# STERLING RANCH EAST PUD DEVELOPMENT PLAN/PRELIMINARY PLAN No.2

LETTER OF INTENT

FOURSQUARE AT  
STERLING RANCH  
PUDSP

PUDSP-22-007

**LOCATION**

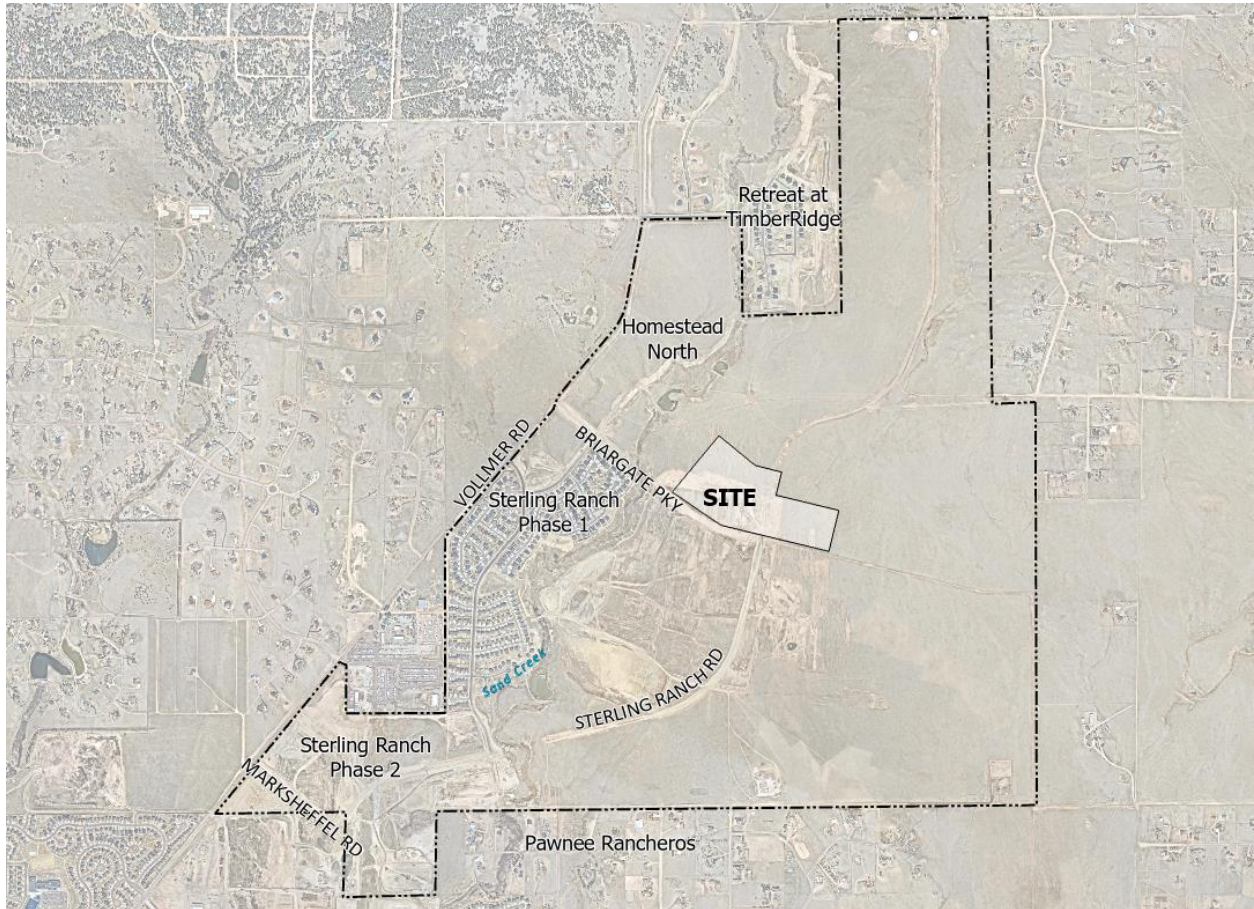
MODIFICATION, WATER SUFFICIENCY, ADMIN  
PLATS, WET UTILITIES? GRADING?
